RE: Joint Livingston Restoration Group (LRG) and BNSF Railway Company (BNSF)  
Submittal -Final Air Sparge/Soil Vapor Extraction Pilot Test Work Plan- Burlington Northern  
Livingston Shop Complex (September 2015)

**FINAL  
AIR SPARGE / SOIL VAPOR EXTRACTION  
PILOT TEST WORK PLAN**

*Burlington Northern Livingston Shop Complex Facility,  
Livingston, Montana*

<b>SINGLE WELL INJECTION TEST AND SVE STEP TEST LAYOUT</b>	
<i>BN Livingston Shop Complex</i>	
Job#: LRGM01 Task 3	<b>FIGURE 3</b>
Date: 9/25/2015	
Path: M:\LRGM01\Task8\Fig3_WorkPlan_FINAL.mxd, Author: jeprowse

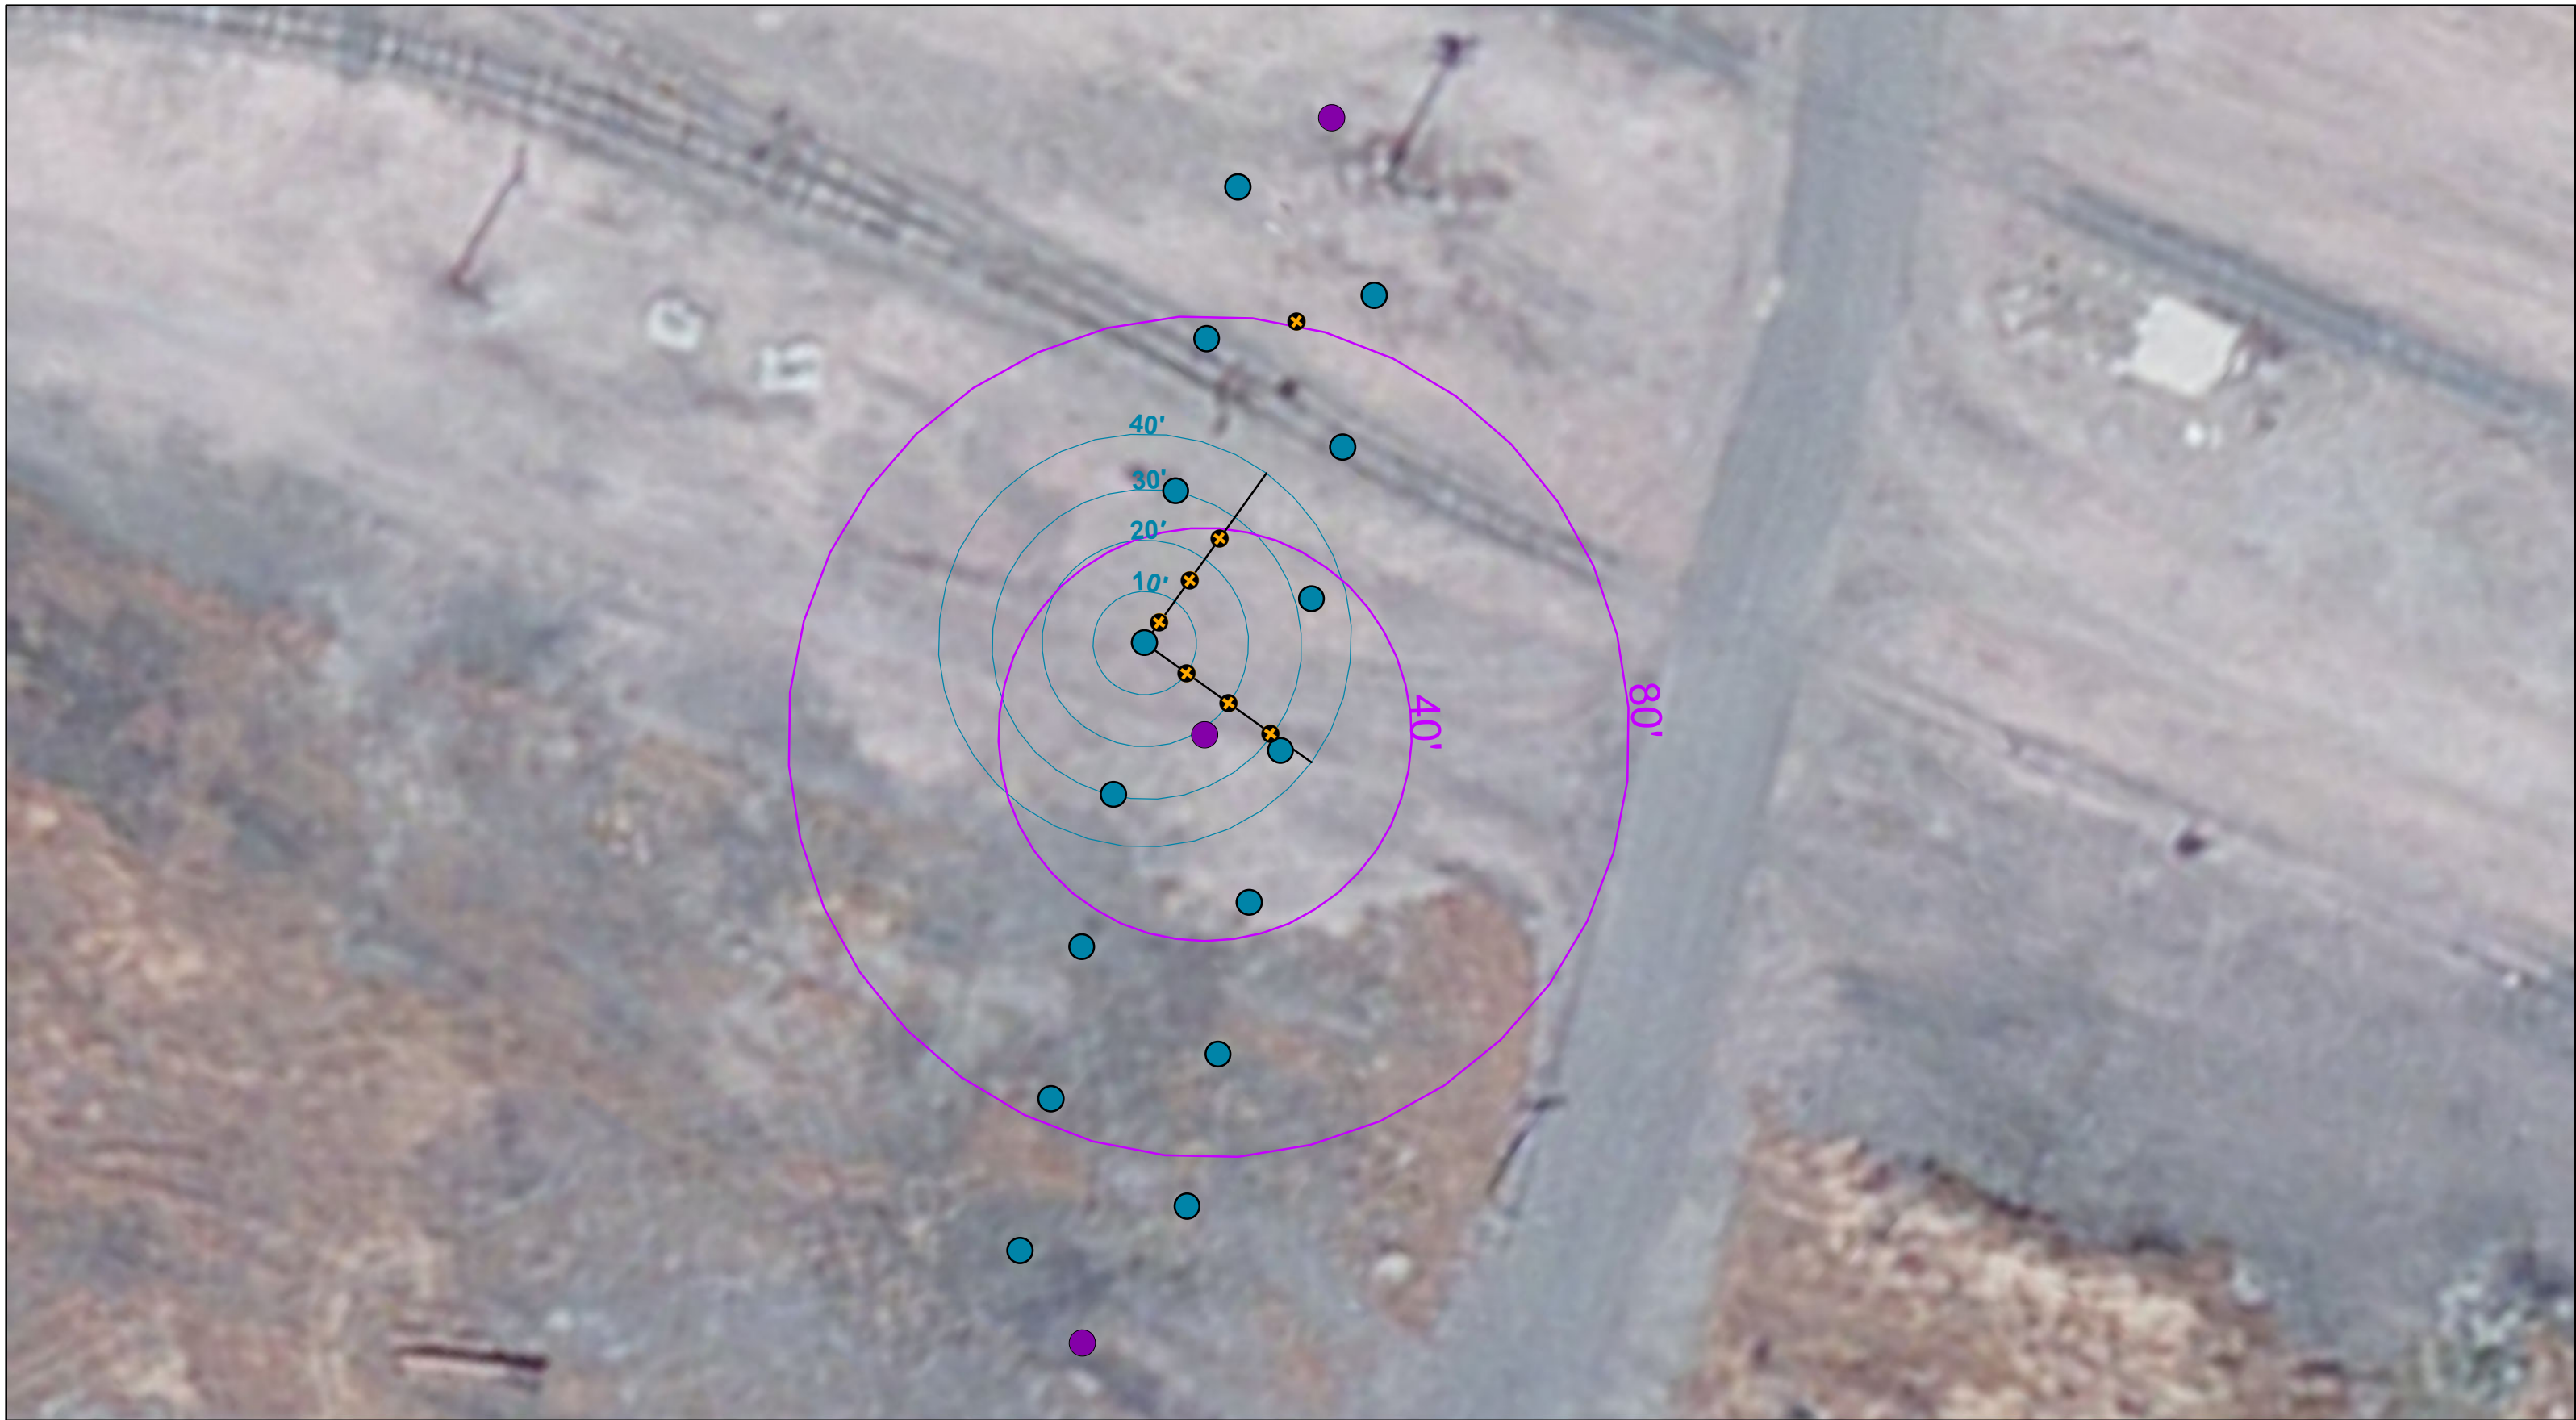
1. Regarding Specific Comment #2: There remains some uncertainty regarding exactly how much radius of influence (ROI) will be achieved in the sparge wells, and the proposed monitoring points are all located at least 20 feet away from the first sparge point. CDM Smith agrees that small changes in permeability can facilitate lateral spread of bubbles, but this spacing assumes at least a 20-ft ROI, despite the fact that the US Army Corps of Engineers (USACE) Engineering Manual indicates a smaller ROI is typical. Monitoring points should be located well within the ROI to confirm the ROI, and located at different/staggered distances in the different directions (i.e. not 20 feet in both directions). Please revise the monitoring network accordingly. This will facilitate interpolation of the data to determine the ROI to be used for spacing. Further discussion and planning regarding appropriate well spacing for the next phase should be deferred until the results of the first single-well test are available.

Response: Monitoring point/wells will be adjusted/added to the AS ROI layout. The work plan specifies five monitoring points; three set on a line north of the test well at distances of 20, 30, and 40 feet; two set on a line 90° to the east at distances of 20 and 30 feet. The adjusted monitoring layout will include six monitor wells; three to the north at distances of 5, 15, and 25 feet; and three 90° east of the north line at distances of 10, 20, and 30 feet.

PROCESS DETAIL  
AIR SPARGING SYSTEM

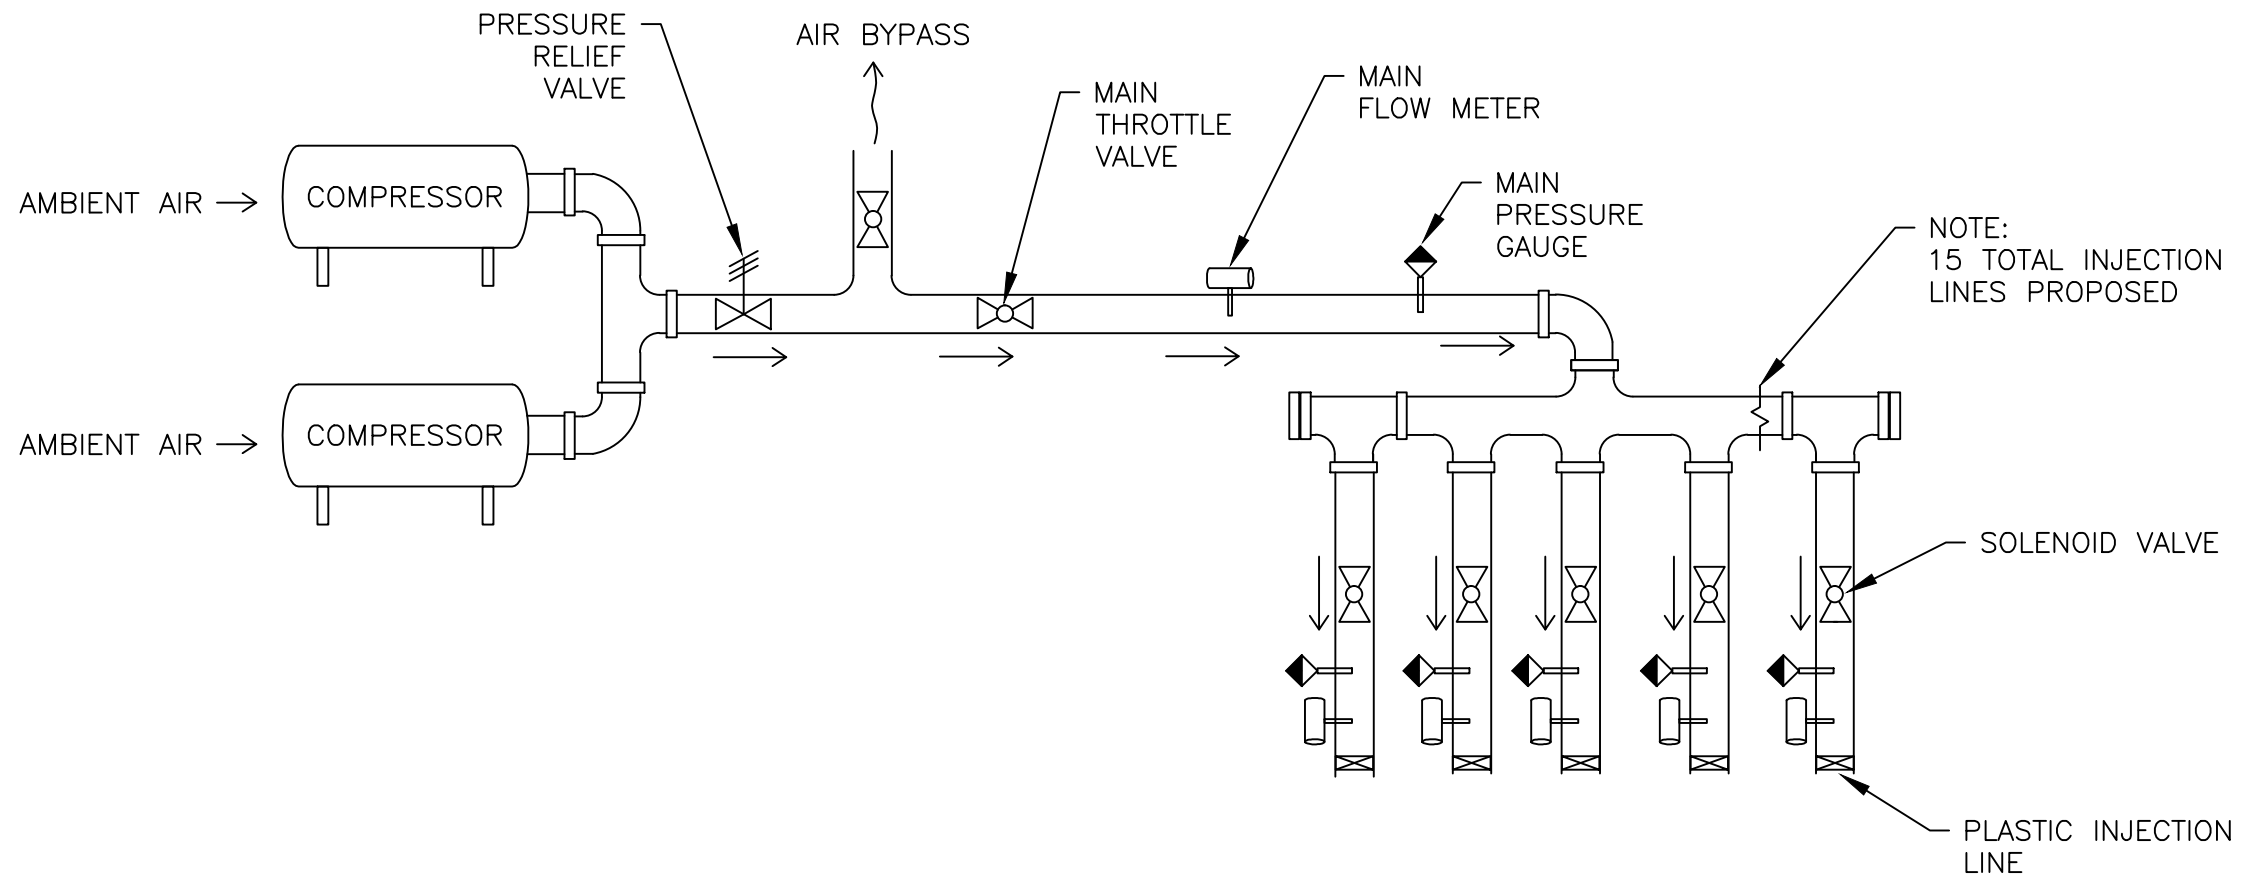
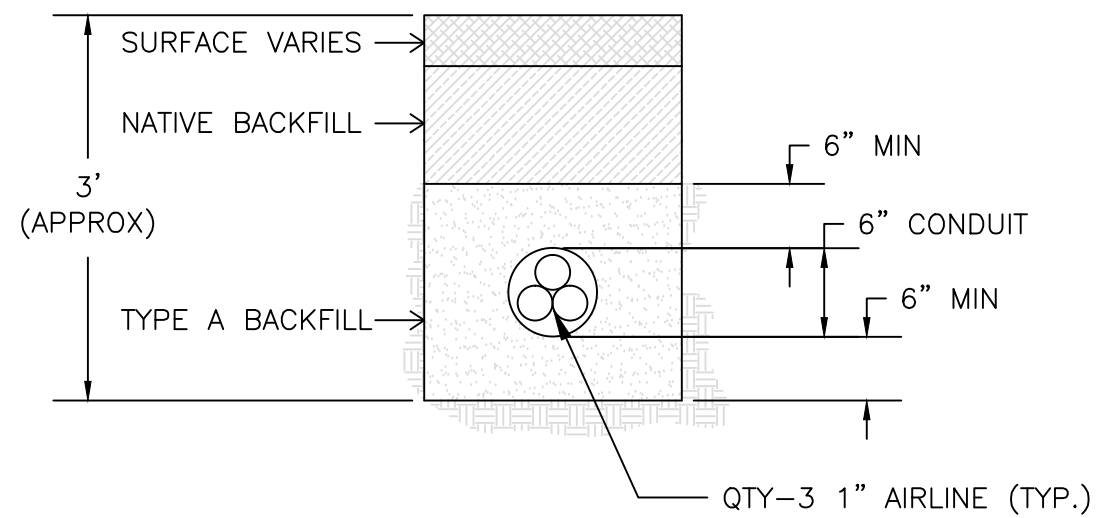
2. Regarding Specific Comment #5: Please install the check valves at the sparging manifold to avoid burial and maintenance issues.

7. Section 3: Helium concentration in the injection gas stream should be maintained at less than 10% to minimize buoyancy/density effects versus air. Please indicate the planned injection rate in the Work Plan.

Response: As a change to the work plan, which specifies a check valve at each well head, this amendment specifies the AS system will have a single check valve placed in the header of the sparge manifold.

Response: Helium will be injected directly into the injection line of the sparge test unit. The helium supply will be equipped with a flow regulator and the air sparge injection line equipped with flow and pressure gauges. A sample port will be placed at the well head to verify helium concentration in the injected air stream at or below 10% by volume.
